Addendum No. 2  
Regional Carrizo Project - Schertz Parkway Pump Station  
SAWS Job No. 10-8617  
SAWS Solicitation No. B-11-061-RA

## **ADDENDUM NO. 2**

March 19, 2012

- A. The purpose of this addendum is to issue revisions to the plans and specifications for the Regional Carrizo Project - Schertz Parkway Pump Station (SAWS Job No. 10-8617; SAWS Solicitation No. B-11-061-RA).

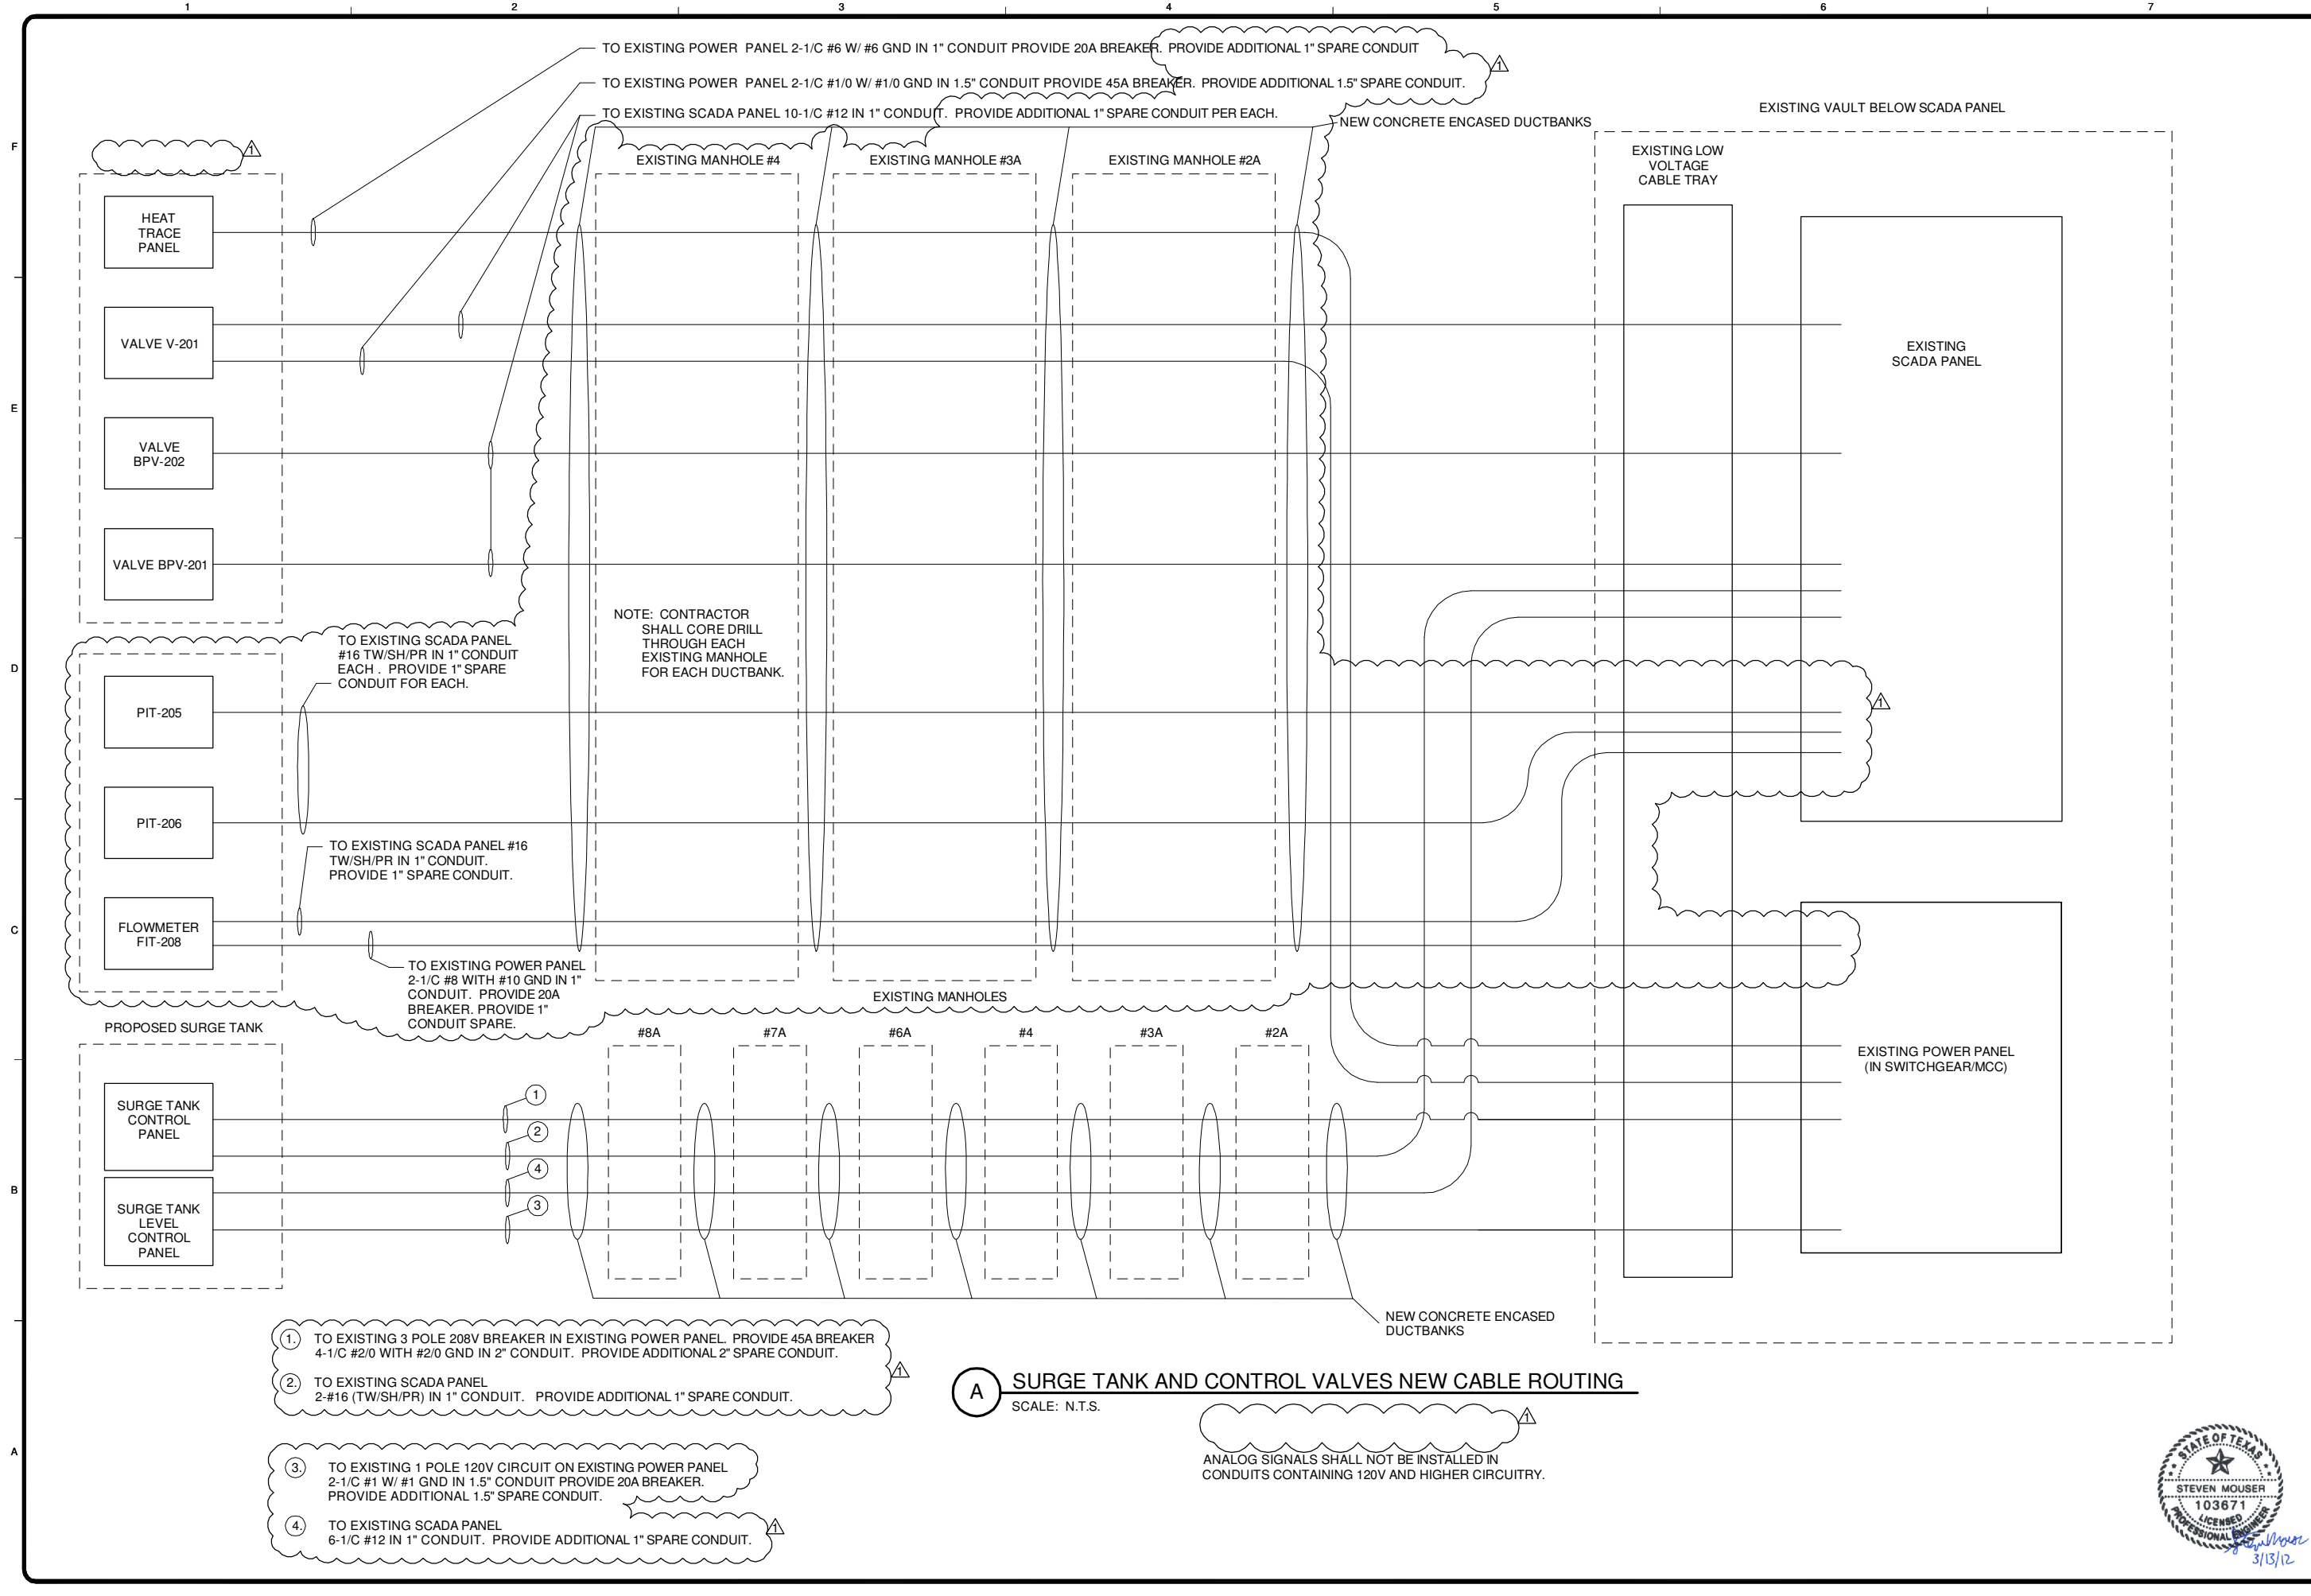
7. Replace Sheet E-151 with new Sheet E-151 included in this Addendum No. 2. Changes are indicated with revision clouds.
- I. Sheet E-152 (117 of 130)
8. Replace Sheet E-152 with new Sheet E-152 included in this Addendum No. 2. Changes are indicated with revision clouds.

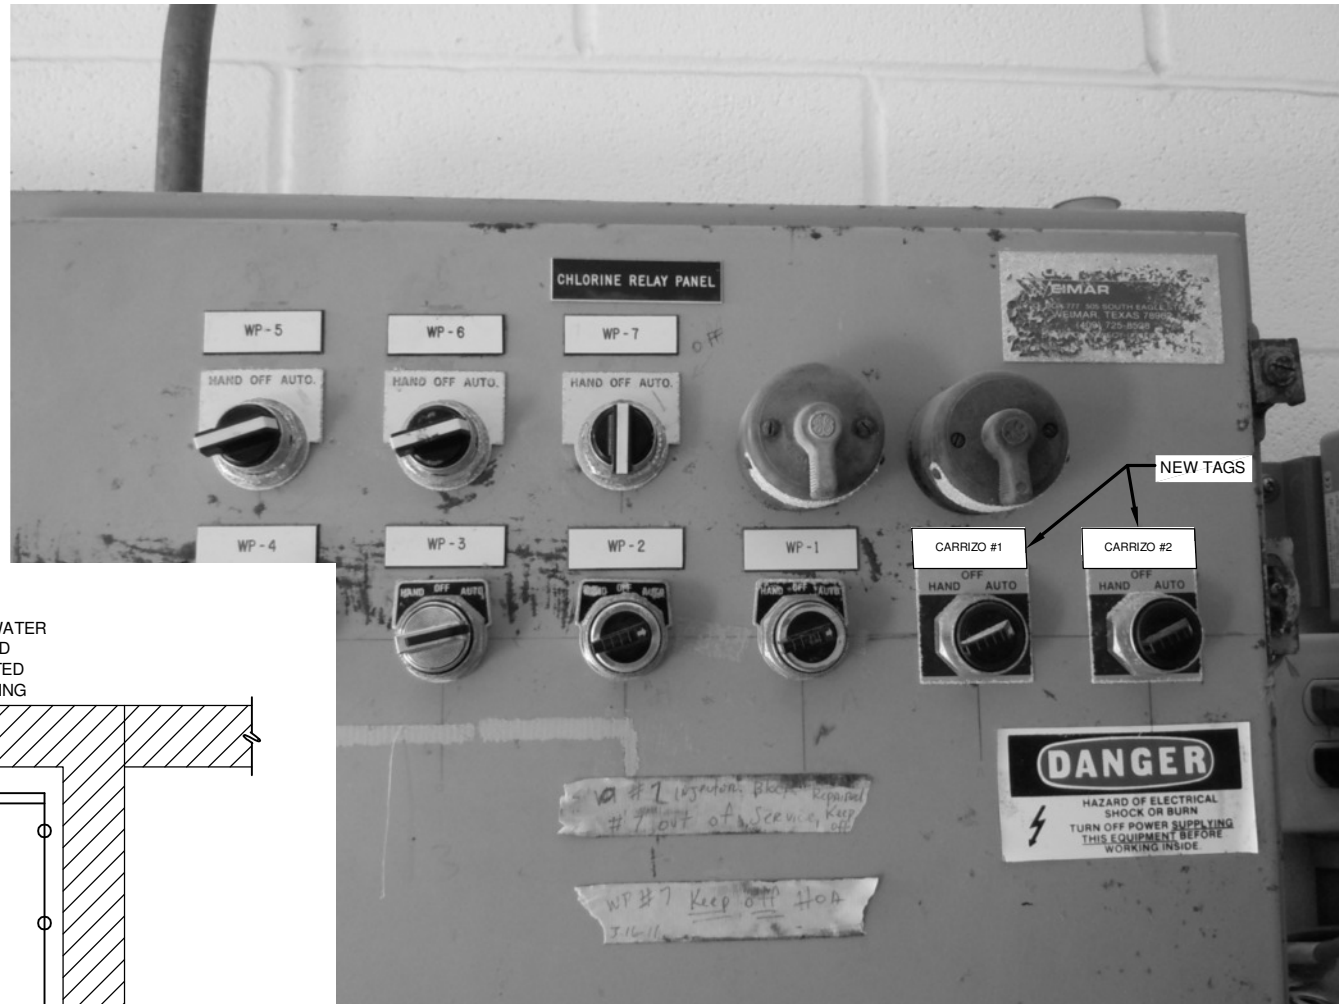
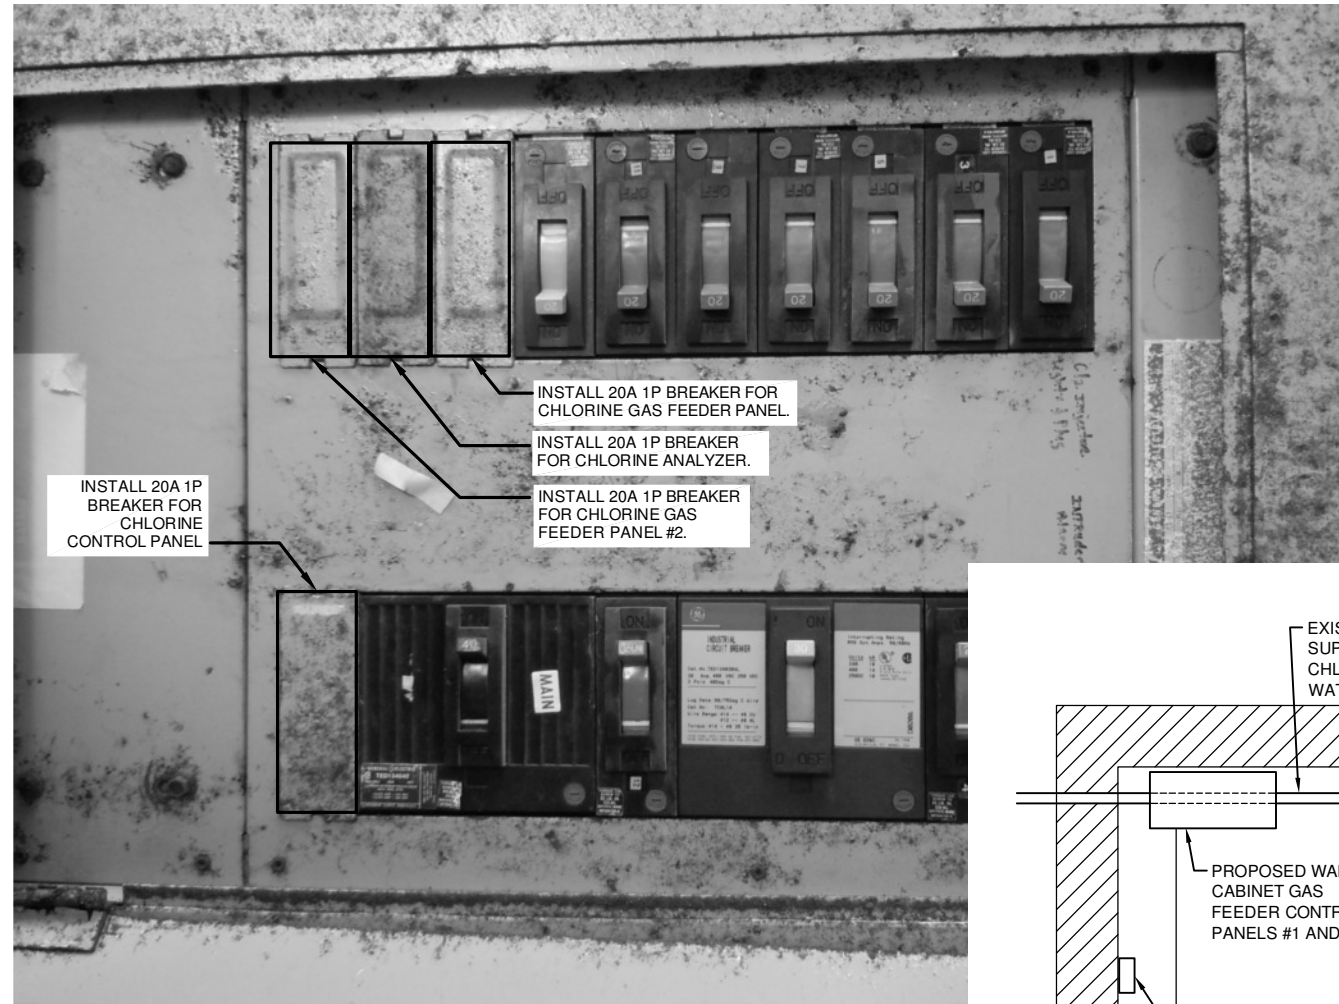
- J. Sheet E-155 (120 of 130)
9. Replace Sheet E-155 with new Sheet E-155 included in this Addendum No. 2. Changes are indicated with revision clouds.
- K. Sheet E-163 (124 of 130)

MODIFICATIONS TO NACO  
CHLORINE PANELS

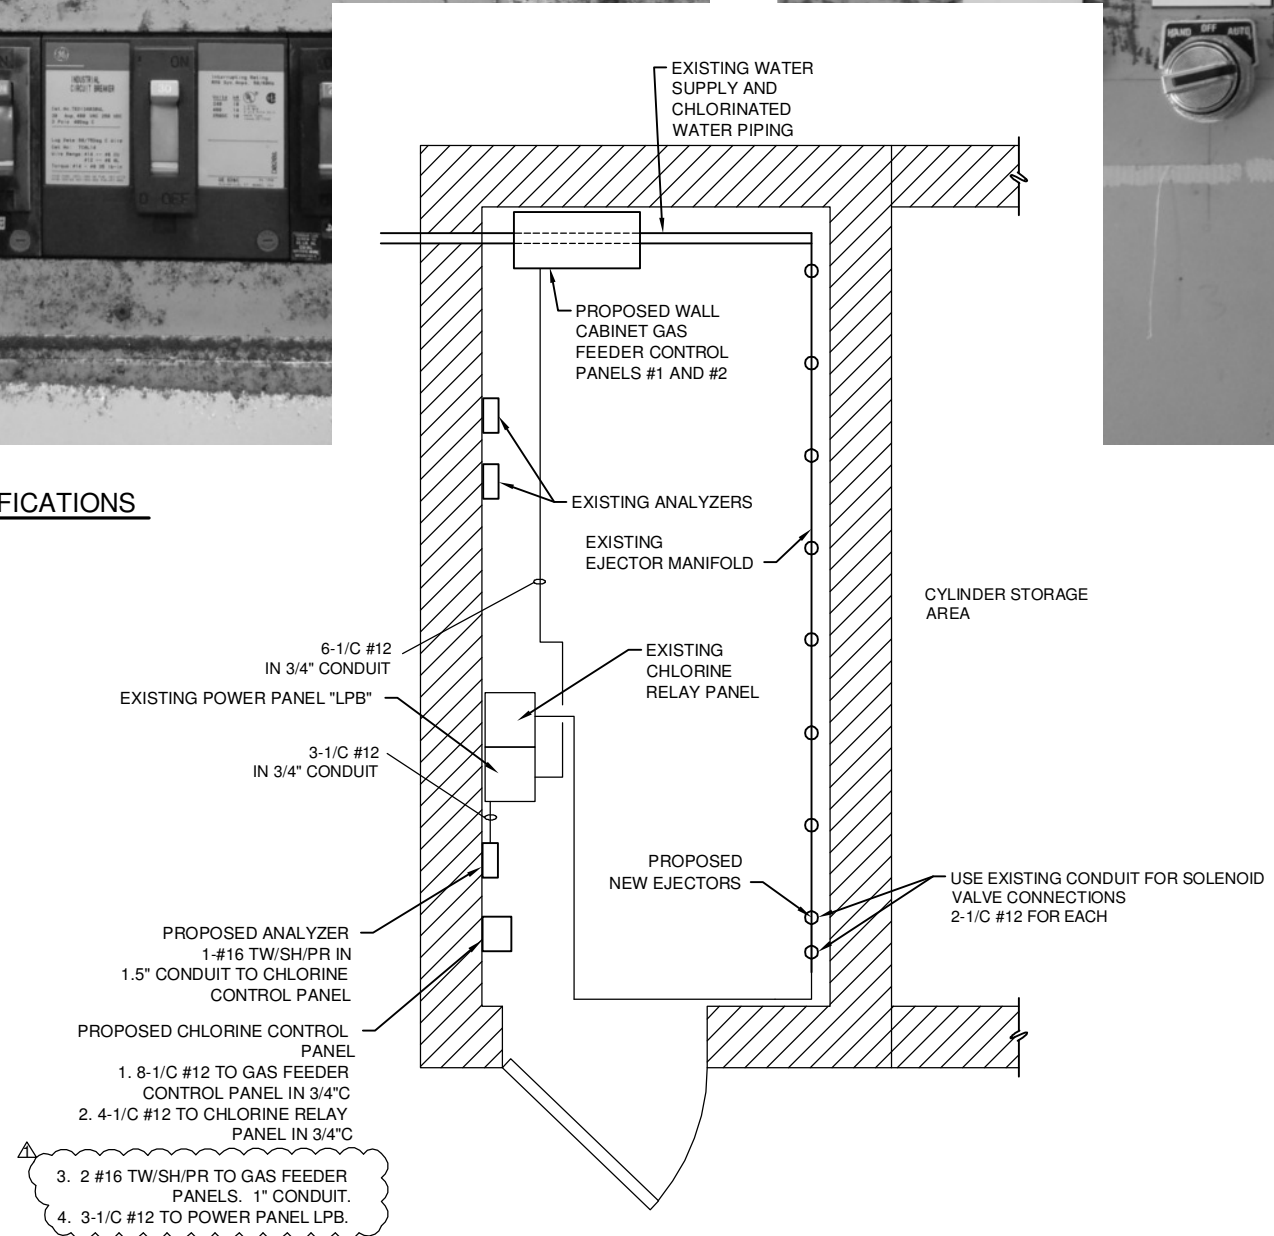
10. Replace Sheet E-163 with new Sheet E-163 included in this Addendum No. 2. Changes are indicated with revision clouds.
